# UNITED STATES PATENT AND TRADEMARK OFFICE

09/895,198

<b>Office Action Summary</b>	<b>Application No.</b> 09/895,198	<b>Applicant(s)</b> MULLER ET AL.	
	<b>Examiner</b> HOA B. TRINH	<b>Art Unit</b> 2893

## DETAILED ACTION

FIG. 1f

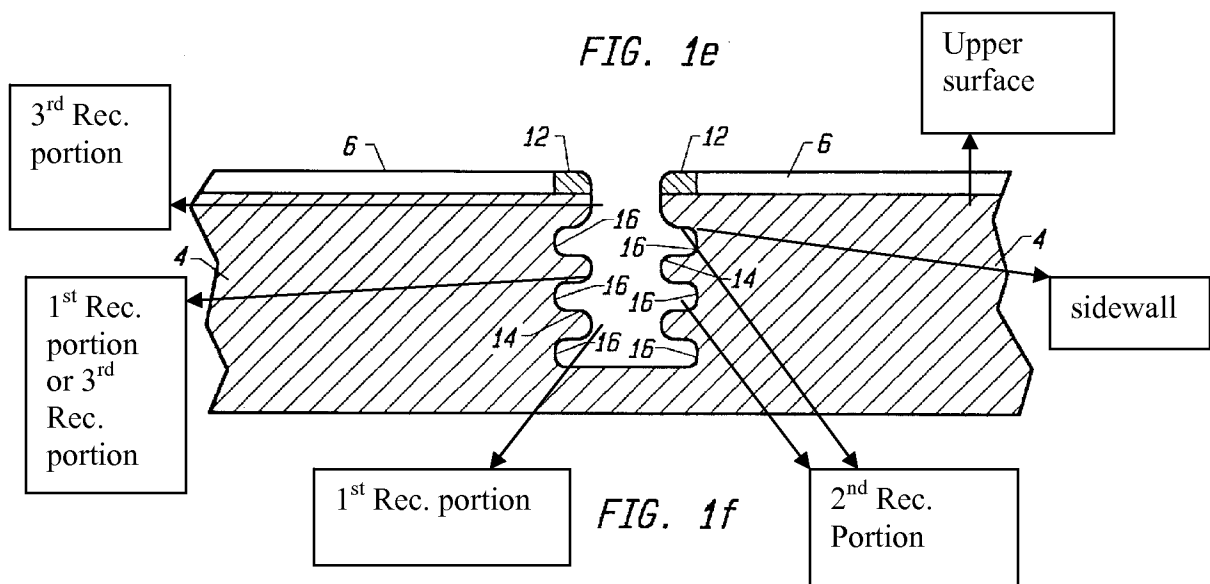
**As to claim 30**, Rostoker discloses an IC structure comprising a substrate 4 (fig. 1f) having an upper surface, wherein said substrate 4 comprises a substrate material 4; an opening (trench, fig. 1f) in the substrate 4 defined by said substrate material 4, wherein borders of the substrate material form a first rectangular portion and a second rectangular portion, wherein the second rectangular portion has a larger dimensions in a horizontal direction than the first and third rectangular portions, wherein said horizontal direction is between sidewalls of said first rectangular portion and said second rectangular portion, wherein said sidewalls are perpendicular to said upper surface; and a conductor 32 (figs. 1f, 3) filling the opening (trench, figs. 1f, 3). See marked-up figure 1f below.

**As to claims 31, 41**, the second rectangular is deeper in the opening (trench; fig. 1f) than the first rectangular portion (fig. 1f). See marked-up figure 1f below.

**As to claims 32, 42**, the first rectangular portion is deeper than the second rectangular portion. See marked-up figure 1f below.

**As to claims 33, 43**, the second rectangular portion increases a surface area of said opening (trench). See marked-up figure 1f below.

**As to claims 34, 44**, the second rectangular portion inherently increases a capacitance of the structure. See marked-up figure 1f below.

**As to claim 35**, Rostoker discloses an IC structure comprising a substrate 4 (fig. 1f) having an upper surface, wherein said substrate 4 comprises a substrate material 4; an opening (trench, fig. 1f) in the substrate 4 defined by said substrate material 4, wherein borders of the substrate material form a first rectangular portion, a second rectangular portion and a third rectangular portion, wherein the second rectangular portion has a larger dimensions in a horizontal direction than the first and third rectangular portions, wherein said horizontal direction is between sidewalls of said first rectangular portion and said second rectangular portion, wherein said sidewalls are perpendicular to said

upper surface; and a conductor 32 (figs. 1f, 3) filling the opening (trench, figs. 1f, 3). See marked-up figure 1f below.

**As to claim 36**, said second rectangular portion is between said first rectangular portion and said third rectangular portion. See marked-up figure 1f below.

**As to claim 37**, said first rectangular portion and said third rectangular portion have substantially similar dimensions. See marked-up figure 1f below.

**As to claim 38**, said second rectangular portion increases increase a surface area of said structure. See marked-up figure 1f below.

**As to claim 39**, the first rectangular portion and the third rectangular portion have different dimensions (fig. 1f) in said horizontal direction. See marked-up figure 1f below.

**As to claim 40**, Rostoker discloses an IC structure comprising a substrate 4 (fig. 1f) having an upper surface, wherein said substrate 4 comprises a substrate material 4; a bottled shaped opening (trench, fig. 1f) in the substrate 4 defined by said substrate material 4, wherein borders of the substrate material form a first rectangular portion and a second rectangular portion, wherein the second rectangular portion has a larger dimensions in a horizontal direction than the first and third rectangular portions, wherein

said horizontal direction is between sidewalls of said first rectangular portion and said second rectangular portion, wherein said sidewalls are perpendicular to said upper surface; and a conductor 32 (figs. 1f, 3) filling the opening (trench, figs. 1f, 3). See marked-up figure 1f below.
